To: INCITS Technical Committee T10
 From: Kevin Butt
 Date: Thursday, June 11, 2009 2:16 pm
 Document: T10/08-391r3 — SSC-3: Resolution to LB IBM-L1

This proposal intends to resolve LB IBM-L21:

Encryption Parameters in a SCSI device

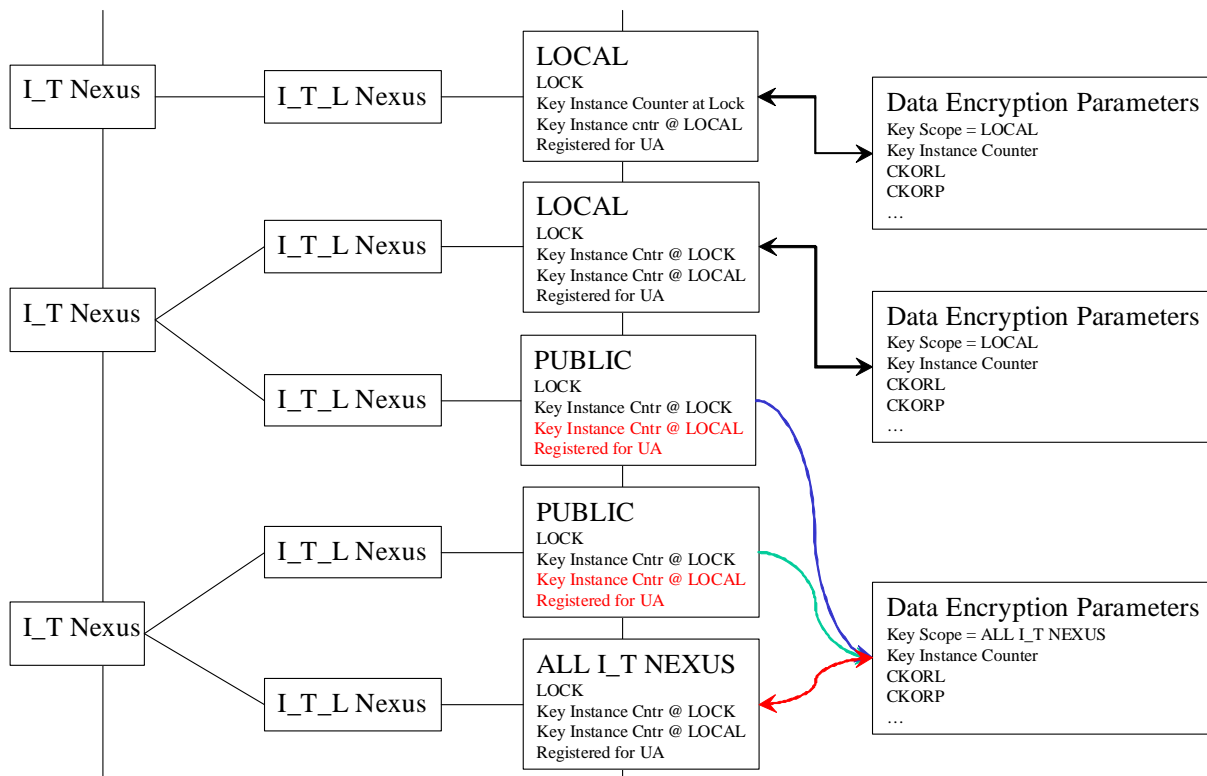
The discussion of this topic, as well as the writing of this proposal, has been very confusing. This proposal needs close scrutiny to make sure it meets the intent of the LOCK bit and the data encryption scope. Paul Entzel believes the proposed solution in the actual letter ballot comment to be incorrect. I agree it is, at least incomplete. The interactions between the LOCK bit, the data encryption parameters and the saved information per I_T nexus are not clear and need to be clarified. These issues are all inter-related to the issue that drove the LB comment about the LOCK bit.

The following figure may help discuss the LOCK bit and what is required for it to function properly. Note that the red text in the figure are parameters that are not present in the specific case.
